Parcel 12

BCDC Subcommittee Meeting 02

MAY 14, 2019

EPNF Proposal

WHAT WE HEARD

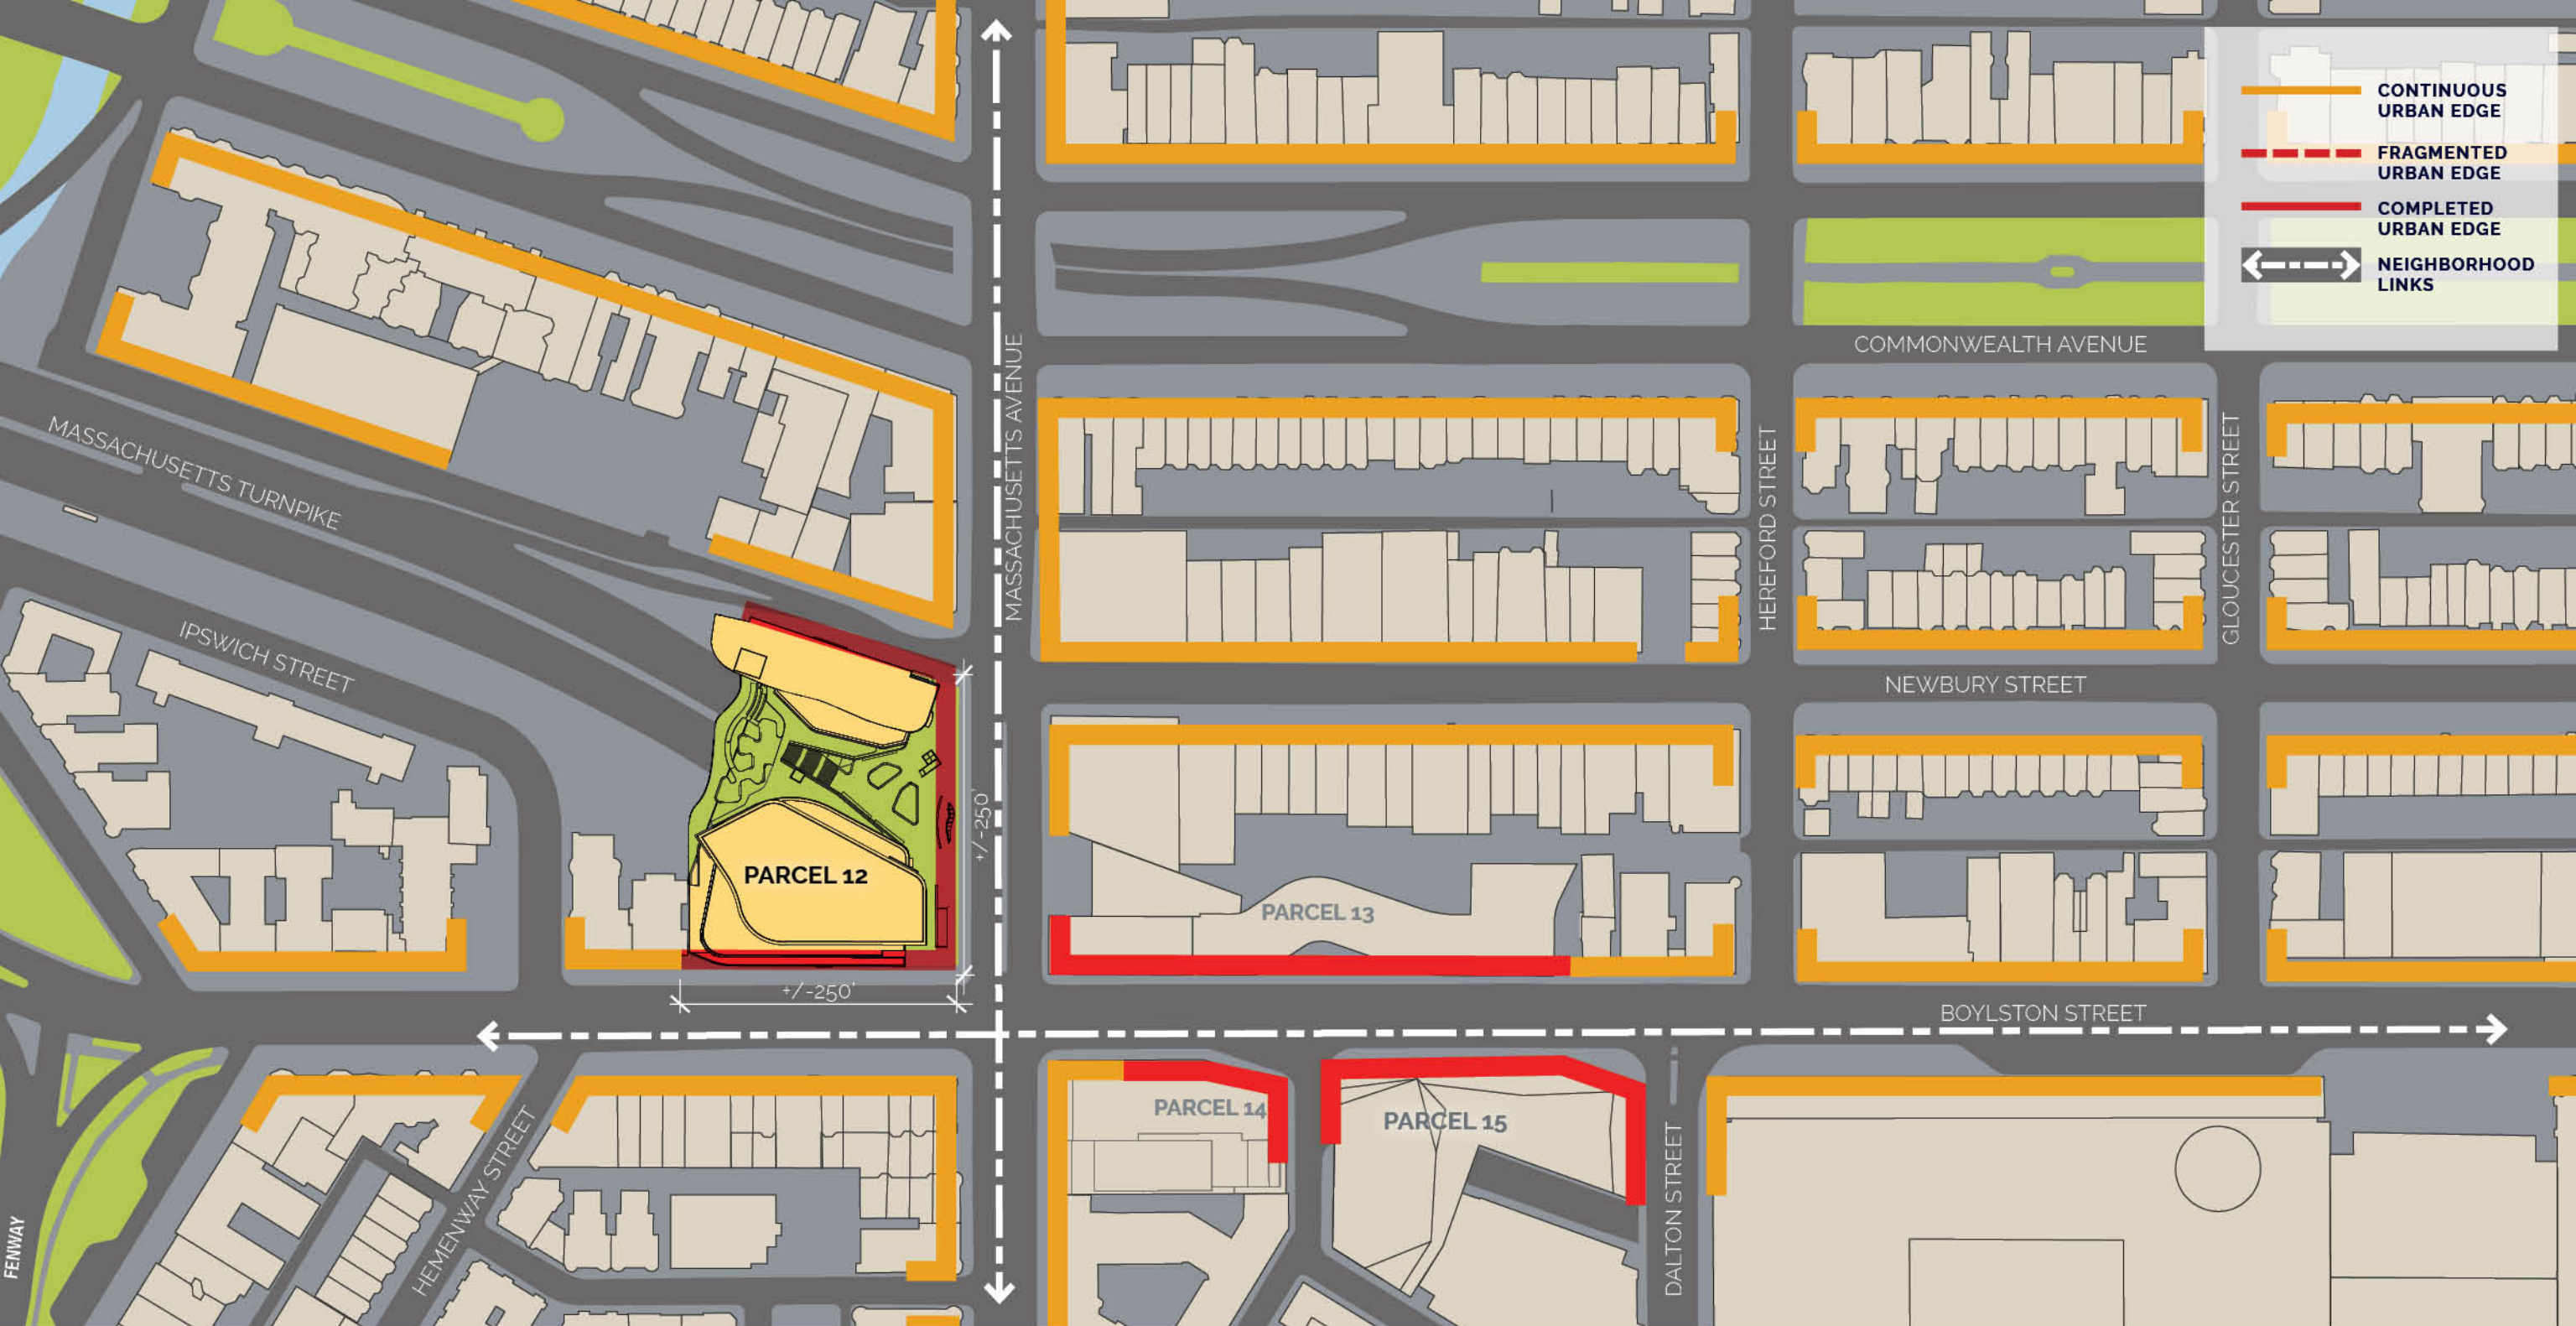
- Questioned the language of a podium with towers floating above. The vocabulary should be re-thought and not resort to an older paradigm.
- The towers should engage the ground and become rooted in the community.
- The direction of the massing and architectural expression of the two buildings needs further discussion. The buildings are too different and should talk more to one another.
- The MassPike view is critical view for the Project and the City. The Project should focus on the Gateway aspect of the massing.
- Regarding the project as a gateway into the city from the west, consider texture, green materials and the composition of the whole, not just massing of the elements.
- The diagonal recessed balconies detract from the office building. They appear to be in conflict with the vertical expression.

WHAT WE HEARD

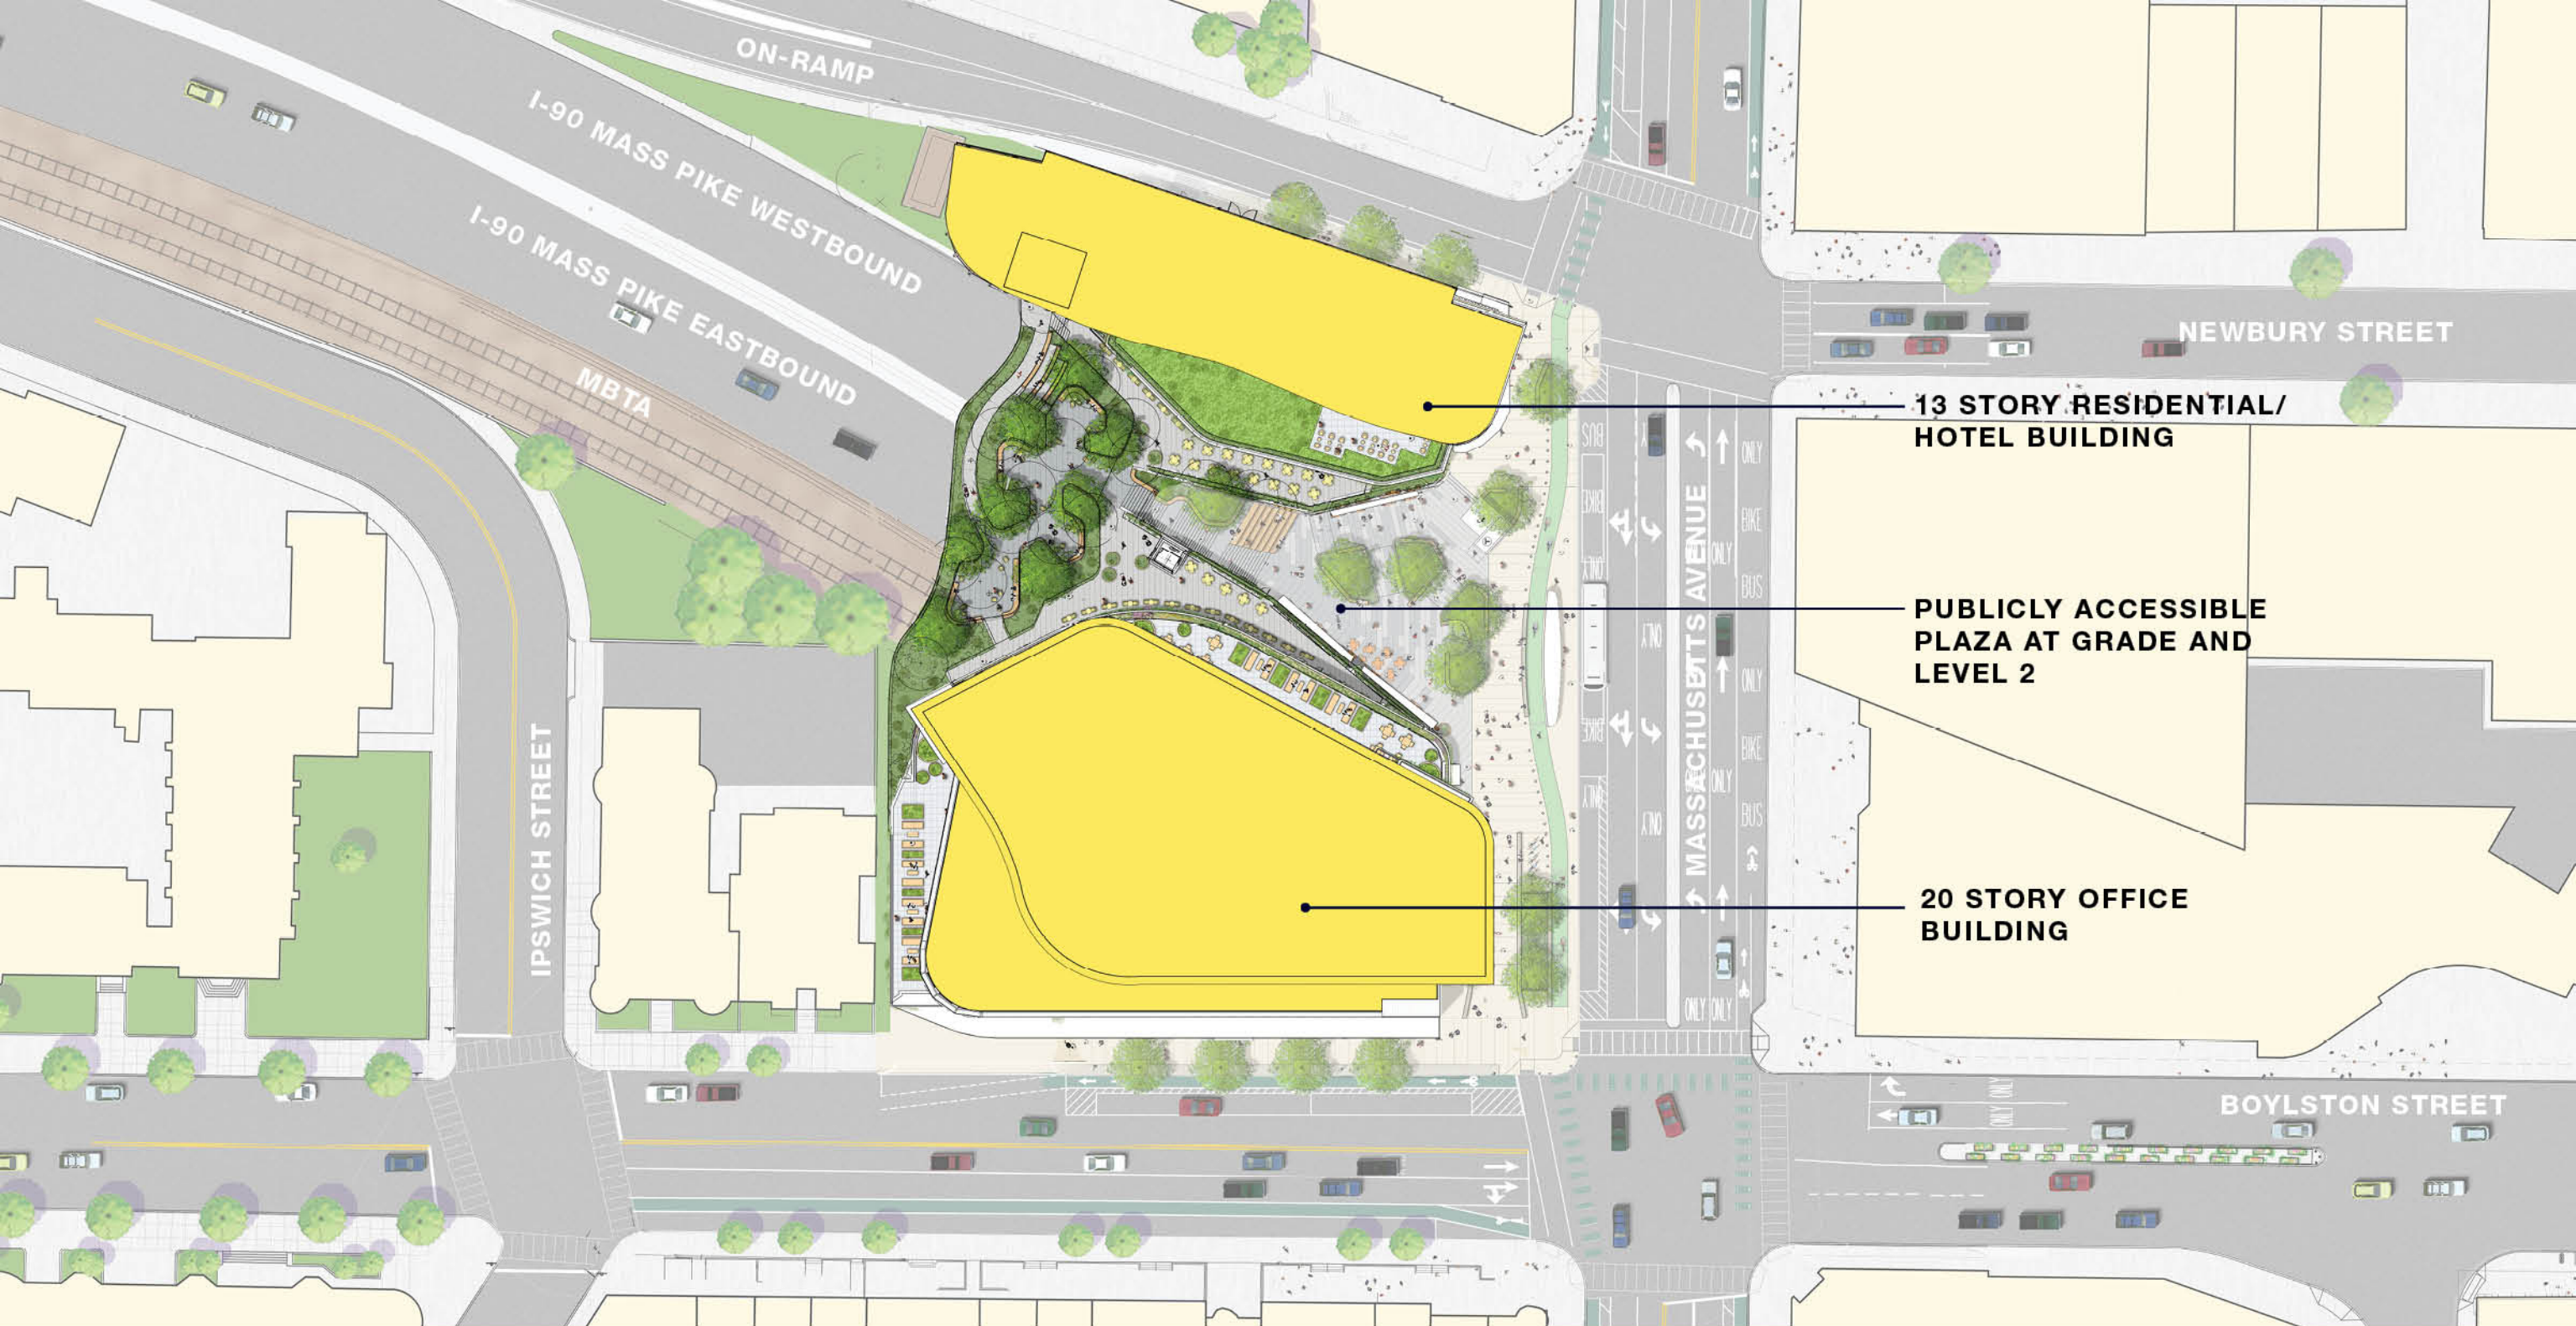
- Study the placement of the T headhouse. Clarify the route for the pedestrian that wants to simply pass through without engaging the plaza
- Curved cycle track is a potential safety hazard; can be improved with straight sightlines
- Study the design of the MBTA head house; try integrating it into landscape elements
- The stair could be a bigger part of the design / experience
- Study the materiality of the western wind screen at the upper plaza; glass will get dirty
- Need more information on wind at the plaza; could be too cold and shady
- Study the relationship of the upper and lower plazas; the lower plaza has too much circulation and not enough plaza; seating on the stairs will want thinner trees for sightlines
- Study a connection from Boylston Street to the plaza
